Amendment Report
New high school in Bungendore
SSD-14394209

On behalf of
NSW Department of Education
September 2022

Table 4. Revised Colour Scheme

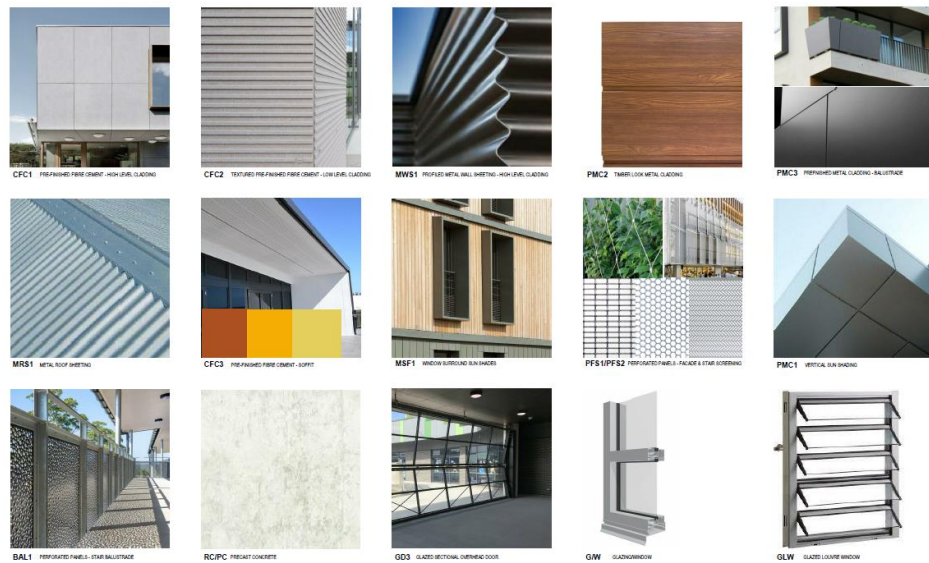
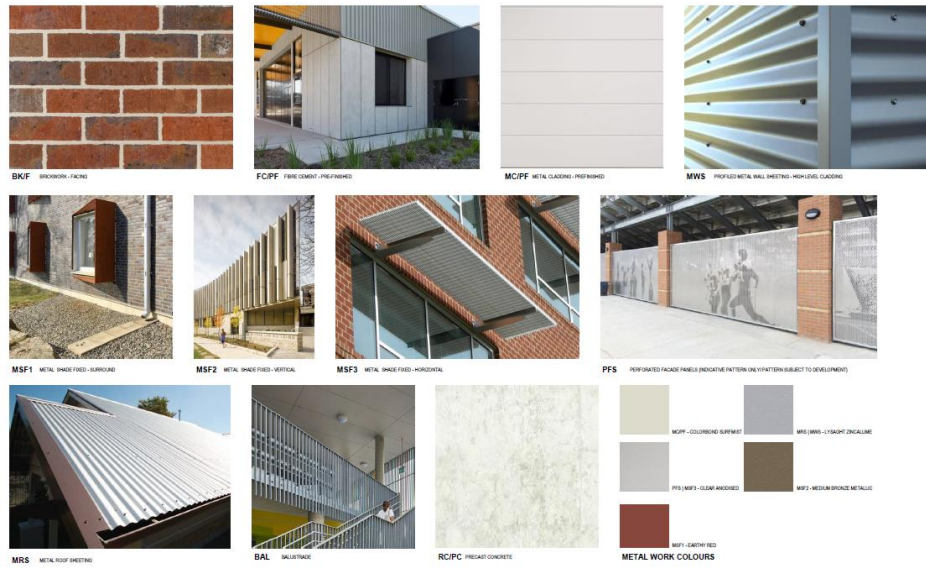
The proposal has been amended to address concerns raised regarding the colours and finishes proposed. The amendment to the colour scheme and finishes (**Table 3** and **Table 4**) ensures consistency with the established rural village character of Bungendore. The revised materiality is discussed further with detailed perspectives in the Architectural and Landscape Design Report prepared by TKD (**Appendix 1b**).

- Corrugated metal walling has been retained to the high-level walling of Block D and to Block F, located on the Agricultural Plot. Corrugated metal roofing is proposed to each of the new buildings. The built form of Blocks A and D have been revised to introduce a lower roof form that wraps around the buildings, providing a sympathetic form that relates the local verandah vernacular and reduces the scale of the buildings.

Table 5. Revised Landscape Scheme

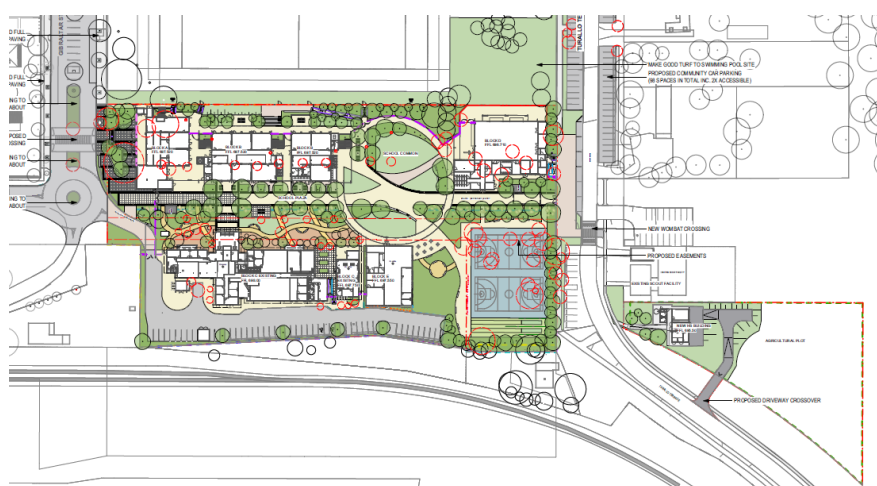
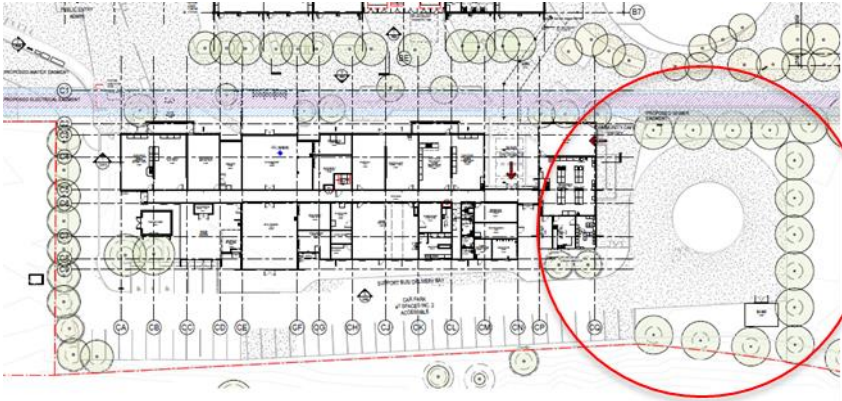
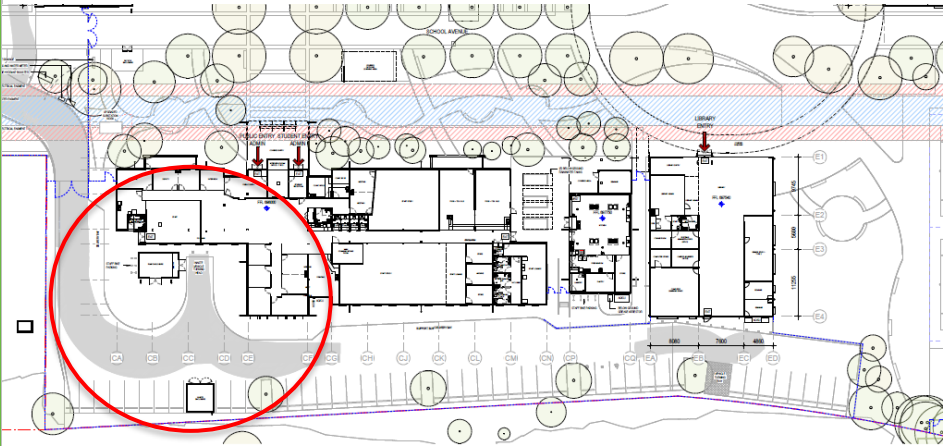
The amendment to the landscaping scheme includes additional planting, reduction in hard stand areas, relocation of covered walkways, removal of bollards and fencing around Mick Sherd Oval and the war memorial, and provision of a through-site connection between the school plaza and Mick Sherd Oval.

The revised proposal increases tree canopy cover within the school site by 50% from the existing conditions, and includes additional trees along site boundaries, within the carpark and within the campus. The increased tree canopy cover will provide biodiversity, shade and amenity for the school.

The landscape design has been revised to increase the site's permeable surfaces. The amended proposal provides approximately 40% of the landscape area of the main campus, as permeable surfaces, which include planting, turf, permeable paving and the bioretention swale. The bioretention swale which lines the Majara Street Axis will capture and treat stormwater run-off.

Table 7. Turallo Terrace Parking, Kiss and Drop, and Wombat Crossing

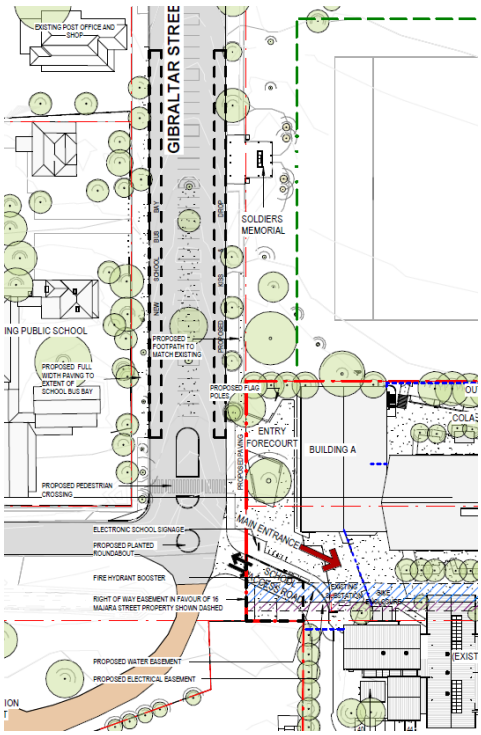
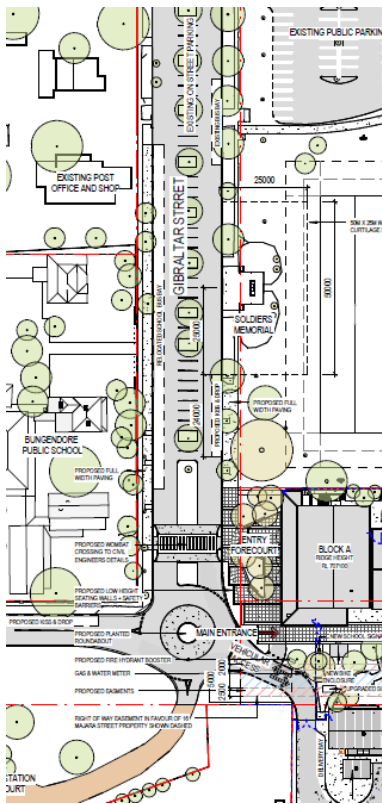
The amendments to the proposal include provision of an additional 58 car parking spaces along Turallo Terrace providing a total of 98 spaces (compared to the original 40). An additional 3 drop off/ pickup spaces are proposed on Turallo Terrace providing a total of 6 spaces (compared with the original 3). A total of 4 drop off/ pickup spaces are provided on Gibraltar Street (**Table 7**).

| Table 8. Majara and Gibraltar Streets Kiss and Drop, and Wombat Crossing | |

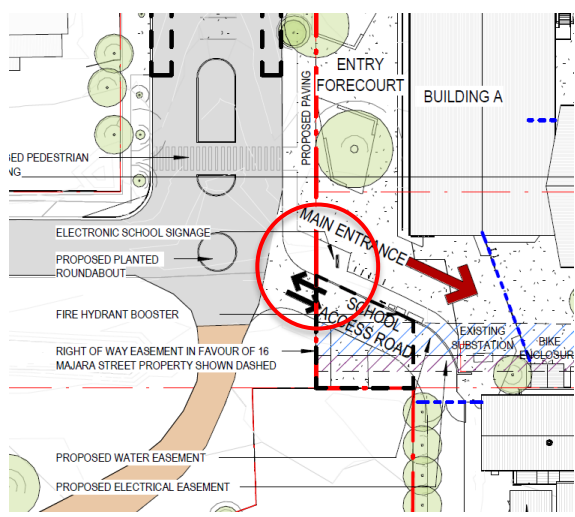
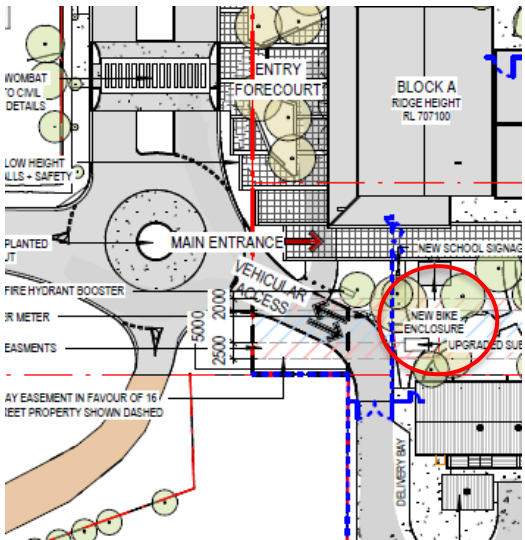
Amendments have also been made on Majara and Gibraltar Streets including removal of the kiss and drop area fronting the War Memorial which have been relocated to the western side of Majara Street. The proposal also includes replacement of the pedestrian crossing with a Wombat Crossing and relocation of the bus bay to the southern side of Gibraltar Street (Table 8).
